Product/Process Change Notice (PCN)																															
<input checked="" type="checkbox"/> Major Change <input type="checkbox"/> Minor Change																															
PCN Number: PCN_TBL Plug 5 mm_20260501 Affected Series: WR-TBL Affected Part Number: see table below PCN Date: 2026-02-02 (YYYY-MM-DD) Effective Date: 2026-05-01 (YYYY-MM-DD)	Change Category: <input type="checkbox"/> Equipment/Location <input type="checkbox"/> General Data <input type="checkbox"/> Material <input type="checkbox"/> Process <input checked="" type="checkbox"/> Product Design <input type="checkbox"/> Shipping/Packaging <input type="checkbox"/> Supplier <input type="checkbox"/> Software																														
Contact: Product Management Phone: +49 (0) 7942 - 945 5001 Fax: +49 (0) 7942 - 945 5179 E-Mail: pcn.eican@we-online.com	Datasheet Change: <input checked="" type="checkbox"/> Yes <input type="checkbox"/> No Attachment: <input checked="" type="checkbox"/> Yes <input type="checkbox"/> No																														
DESCRIPTION OF CHANGE: <p>To improve the processability, Würth Elektronik eiSos will change the production site of WR-TBL series mentioned. This implies changes in d

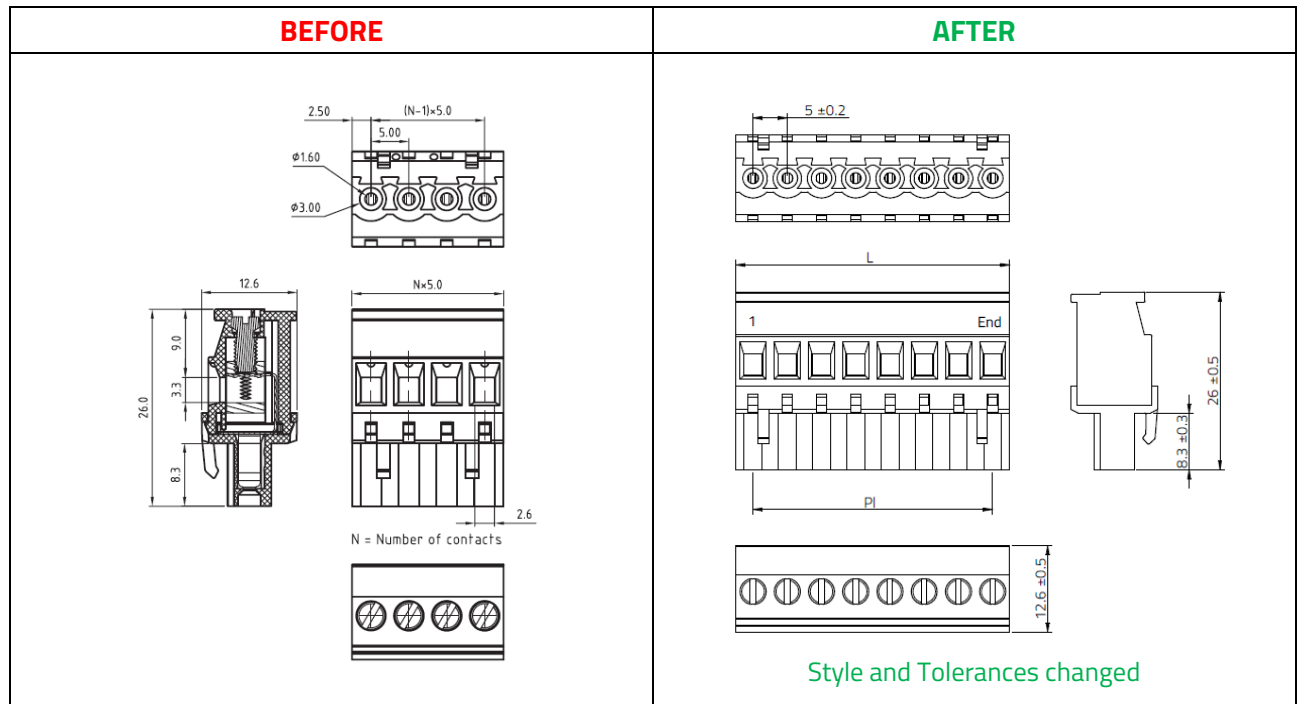
1. Specifications

a. 6913437100xx / 6913527100xx

Rated current UL (A)	Working Voltage UL (V)	Withstandin g Voltage UL (V)	Contact resistance (mΩ) UL	Rated current VDE (A)	Working Voltage VDE (V)	Withstandin g Voltage VDE (V)	Contact resistance (mΩ) VDE
BEFORE	20	300	1600	20	20	300	2500	20
AFTER	15	300	1600	20	15	320	2200	20

e. 6913517000xx

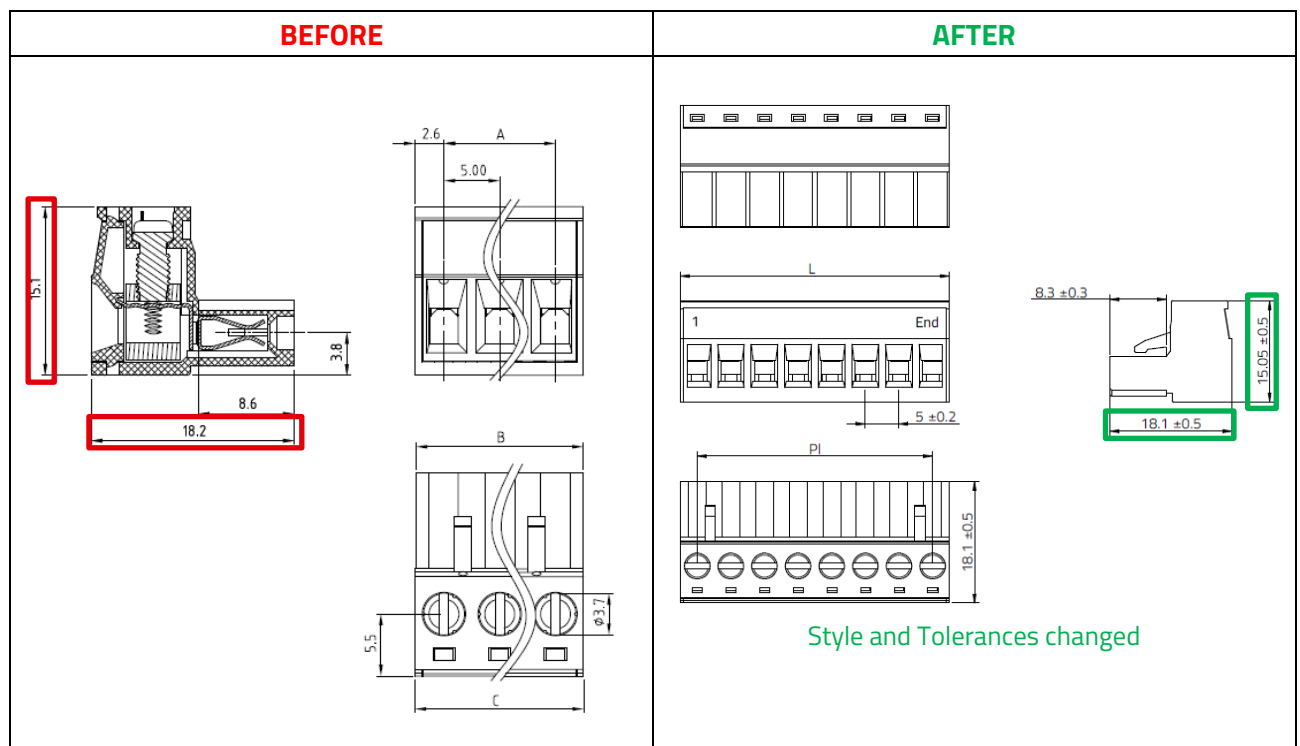
The production line can be identified by the first three digits of the lot number: **XXX XXX XXX XXX XXX**

Previous production line:	New production line:
Lot number: 222 XXX XXX XXX XXX Country of origin on Delivery Note: China	Lot number: 653 XXX XXX XXX XXX Country of origin on Delivery Note: China
